ROAD SAFETY AUDIT OF MUMBAI METRO RAIL CORRIDOR

JULY 2013

Figure 2: Bus stop before pedestrian crossing

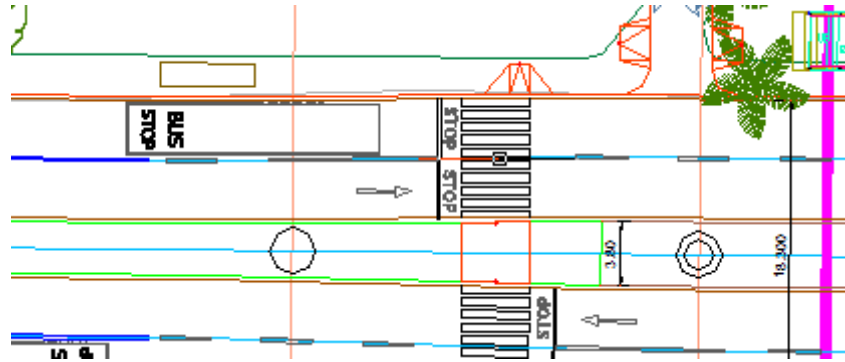
At some instances bus stops are placed just before a pedestrian crossing. This reduces the visibility of pedestrians from vehicles passing the bus stop.

Bus stops should be placed after pedestrian crossings.

Figure 4: Changes in sidewalk level due to gates close to each other

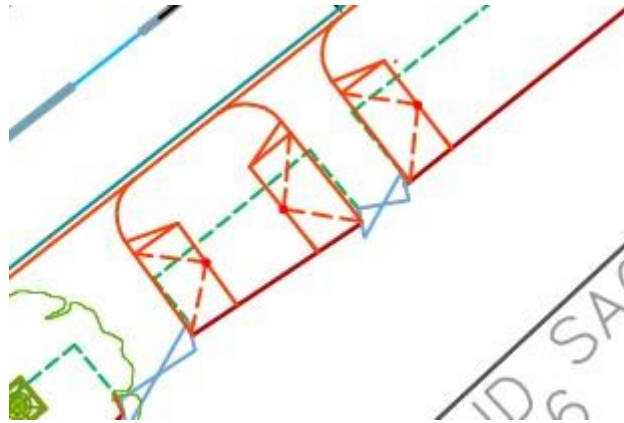
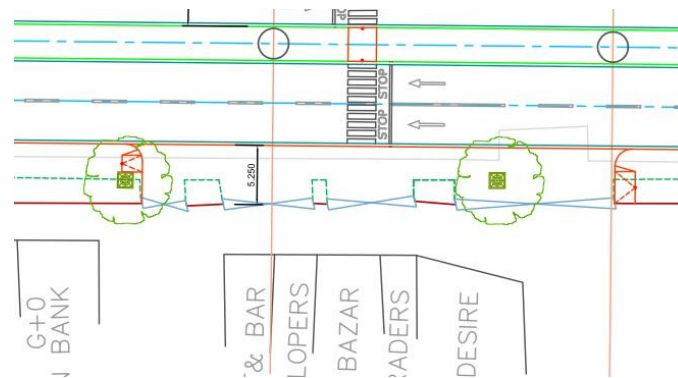
At accesses to properties the sidewalk is cut off so that the access is at street level. This means that accesses work as side roads and vehicles can turn at some speed. Also, the sidewalk is often interrupted and does not provide safe passage for pedestrians.

The sidewalk should be kept at the same level between side roads along the corridor, prioritizing pedestrians. A raised sidewalk will reduce the speed of turning vehicles. Where this recommendation cannot be followed accesses should be reconsidered to ensure sufficient visibility, width of and access to ramps.

Figure 8: Trees in front of a gate, in the middle of the street and in front of the ramps

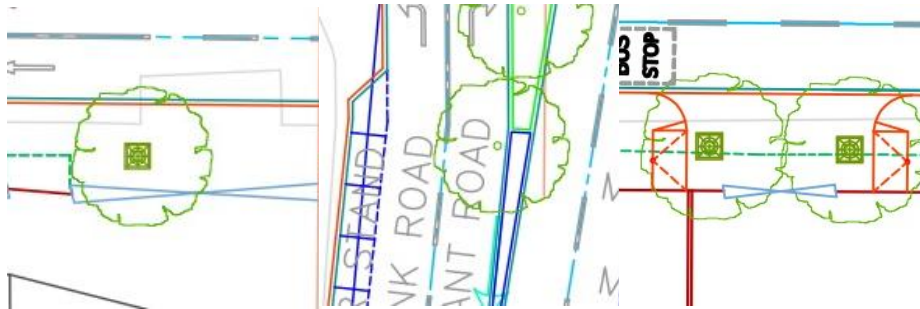
It was noticed that some trees shown in the project are not in appropriate places. Some of them are in front of ramps, property gates or even in the middle of the street. It was not clear if they are going to be removed or if they are going to be kept in the project.

The trees should not be an obstacle to pedestrians or other road users. If the project includes the trees, the infrastructure around them should be planned and built in a way that will not be obstructed by the trees. Otherwise, they should be removed.

Figure 9: Intersection with large turning radii

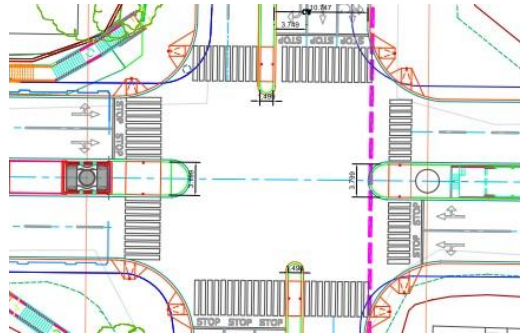
At some intersections or near the property gates, the turning radius is too wide. This should be avoided, as vehicles are likely to use higher speeds to turn instead of decelerating, which would be the safer way to turn.

To ensure that vehicles make the turning movements at lower speeds, the turning radius should be as small as possible. This can be done through the widening of sidewalks and extension of the central medians.

Figure 10: Property gate under the station's stairs

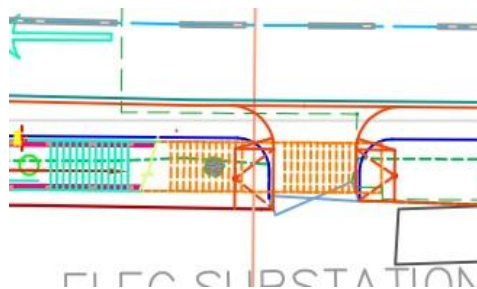
Under some stairs on the stations there are property gates. Vehicles leaving the gates may not have appropriate visibility of the street and oncoming vehicles and pedestrians due to these stairs, and they may also not be seen by the main road users.

The property gates under the stairs should be properly signalled, to alert drivers on the street about the vehicles leaving the gate. The approach should also allow drivers leaving the gate to have an appropriate visibility of the main road and pedestrians crossing the area in front of the gates.

Figure 13: Property gate too close to the intersection and near trees

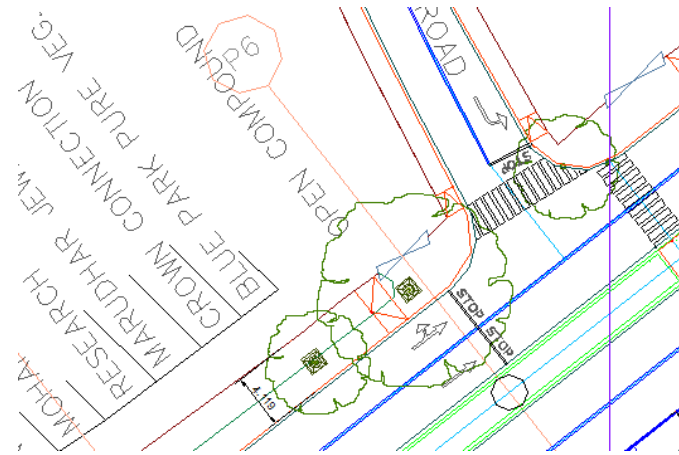
There is a property gate at J.P. Road, close to the intersection with Vasvani Road. It may create conflicts between vehicles using the main road and vehicles leaving the property. Two trees on the sidewalk blocks visibility.

This property gate should be moved to the side road or to a place further from the intersection.

Figure 15: Intersection of J.P. Road and Balasaheb Sawant Road

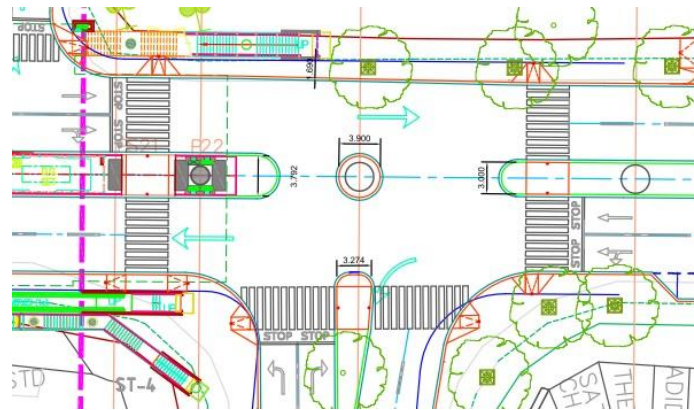
The geometry of the junction is complicated because of the column in the middle. Right-turning vehicles were seen passing on either side of the column from both directions. U-turns are also performed from all directions.

It is recommended to close the central reserve at this point.

Figure 16: Bus stop in front of pedestrian crossing

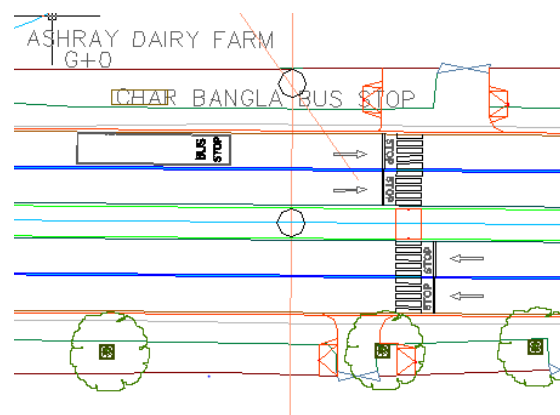
The bus stop at this location is placed before the pedestrian crossing which may reduce visibility.

The pedestrian crossing ends at street level on the northern side. If the recommendation of using raised crossings at mid-block pedestrian crossings is followed the crossing should have a ramp. This would complicate the passage of vehicles for the property gate.

To keep consistency along the project, the bus stop and the pedestrian crossing should shift place. This would allow vehicles to have a better visibility of pedestrians crossing the main road. This would also solve the access problem.

Figure 17: Narrow ramps at pedestrian crossing

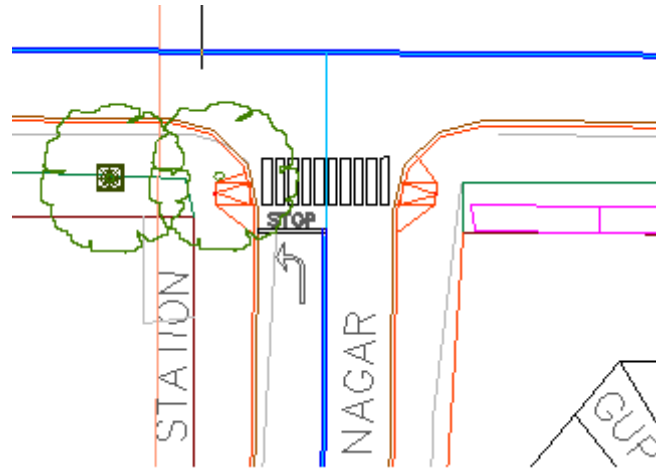
The ramps at the pedestrian crossing in the side road seem to be very narrow.

Check that the width of the ramps is in accordance with Indian standards.

Figure 18: Ramp ends in tree

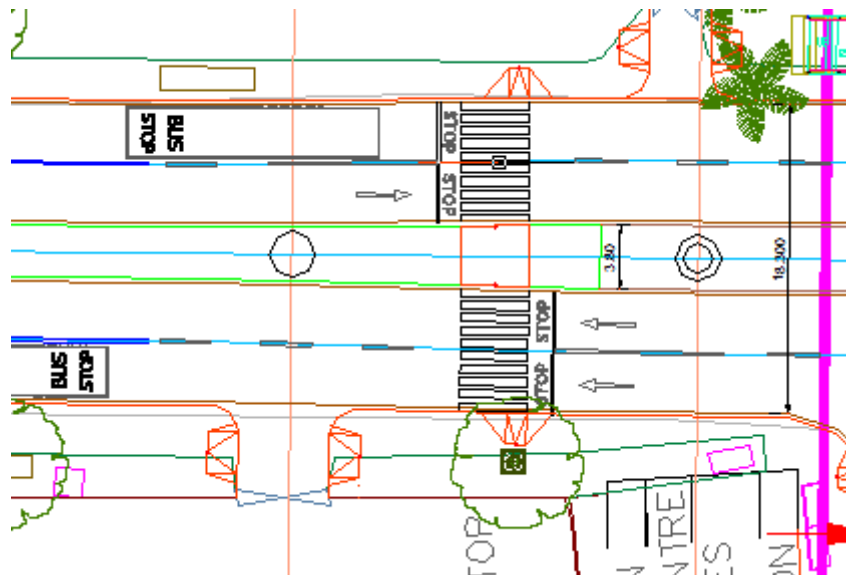
The ramp at the southern end of the pedestrian crossing ends in a tree trunk.

Move the ramp to other side of pedestrian crossing.

Figure 19: Lane markings indicating straight movements only

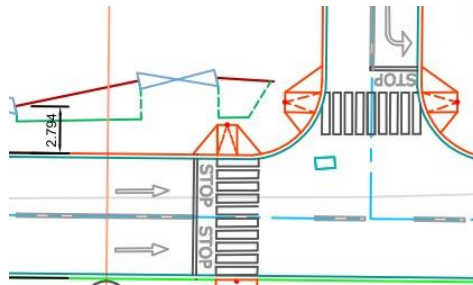
At the intersection of J.P. Road and Bazar Road an arrow in the left lane indicates that the vehicles are only allowed to move straight. Apparently, this lane should allow access to Bazar Road as well.

If left turning movements are allowed at this point, which would not present any safety problems, this arrow should also indicate this movement as a possibility to vehicles approaching to the intersection.

Figure 20: Bus stop far from pedestrian crossing

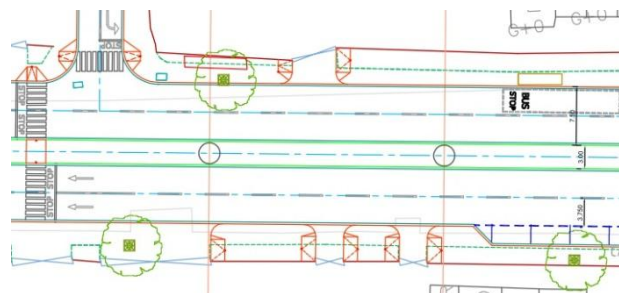
There is a bus stop placed at this point, but there are no pedestrian crossings near it. This is a problem, as bus passengers don't have safe conditions to cross the main road after alighting or when attempting to access the bus stop.

To allow passengers to cross the main road safely, bus stops should always be installed near pedestrian crossings.

Figure 21: Marked turning movements

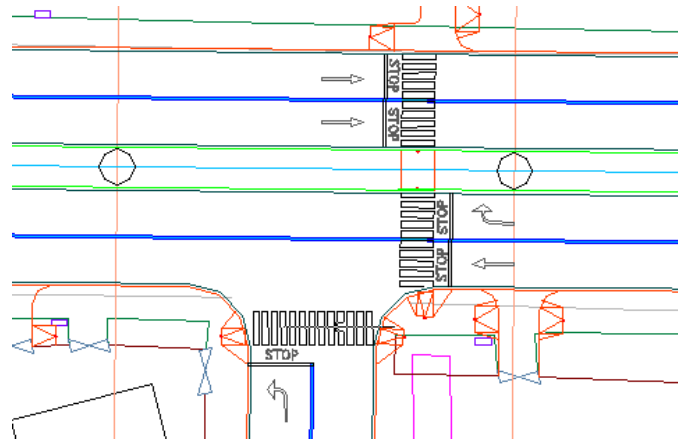
Markings on the southern half of J.P.Road indicate a right turn lane and a lane for going straight. The central reserve does not allow right turn and the side road seems to be bidirectional allowing for left turns.

Replace the markings with a straight arrow in the right lane and a combined straight/left arrow in the left lane.

Figure 22: Pedestrian crossing in front of property gate

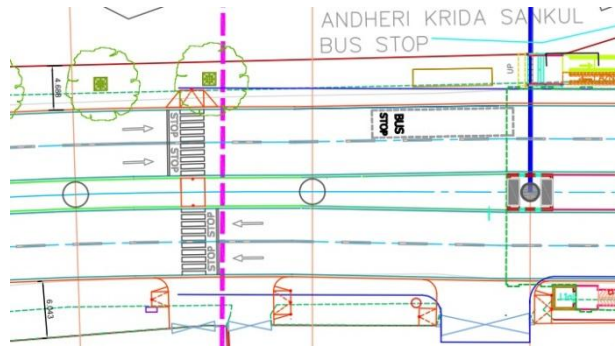
In front of a property gate, there is a pedestrian crossing (see *Pedestrian crossings in front of a property gate*). This crossing is also far from the bus stop and the stairs of the metro station.

The location of the pedestrian crossing should be carefully designed. The crossing should be placed as close as possible to the bus stop and the stairs of the metro station, taking into consideration that pillars may obstruct the visibility of pedestrians waiting to cross. Guardrails should be placed to help guide pedestrians to the crossing.

Figure 23: Arrow indicating allowed right turning

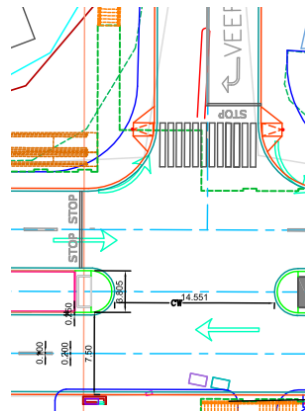
The arrow drawn in one of the lanes of Veera Desai Road indicates that it is allowed to turn right to access the main road, which may create many conflicts between vehicles making this movement and the ones already using J.P. Road.

If the right turning access to the main road is allowed, this intersection should be signal-controlled and the arrow should indicate both right and left turning. Otherwise, the central reserve should be closed and the arrow should indicate left turning instead.

Figure 24: Pedestrian crossing in front of narrow sidewalk

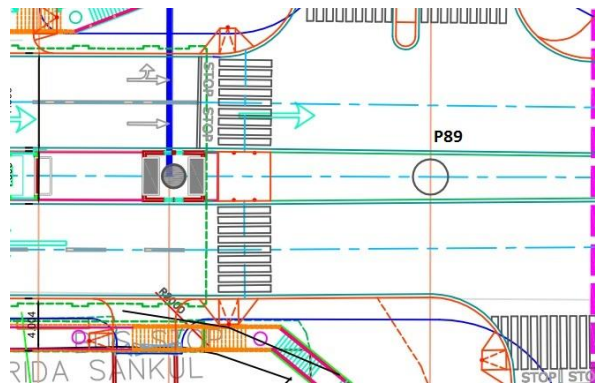
At the second part of the crossing, the sidewalk is too narrow due to the stairs of the metro station. This sidewalk is also too close to a property gate under the stairs, which may obstruct the visibility of vehicles.

The second part of the sidewalk should be staggered to a wider part of the sidewalk (closer to P89).

Figure 25: Arrows in side road indicating left turning

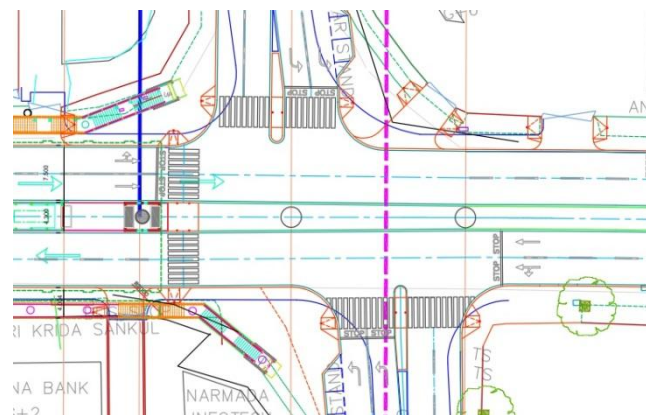
The markings at the two side roads indicate that vehicles at both lanes should turn left and access the main road. If two vehicles try to access J.P. Road at the same time, they may not have an appropriate visibility of the other vehicles at the main road.

If the junction is not signal-controlled, it is recommended to allow only one vehicle at a time to access the main road. This can be done by extending the sidewalks and central islands.

Figure 26: Arrows in main road indicating right turning to access the side road

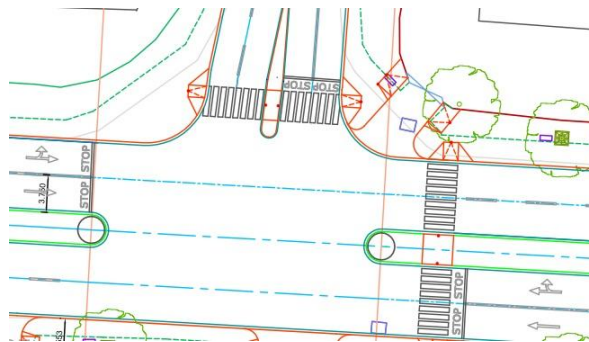
The arrows in the drawing indicate that right turning is allowed from the main road to access the side road. Right turning may create many conflicts between vehicles in different lanes. There are no arrows indicating which movements are allowed to vehicles leaving the side road.

If right turning is allowed from J.P. Road to access the side road, this intersection should be signal-controlled. Otherwise, the arrow in the main road should be changed to one indicating straight movements and the central reserve on the western side should be extended to the middle of the junction.

Road markings should be applied to inform the allowed movements to drivers coming from the side road. Right turn movements should not be allowed unless the junction is signal-controlled.
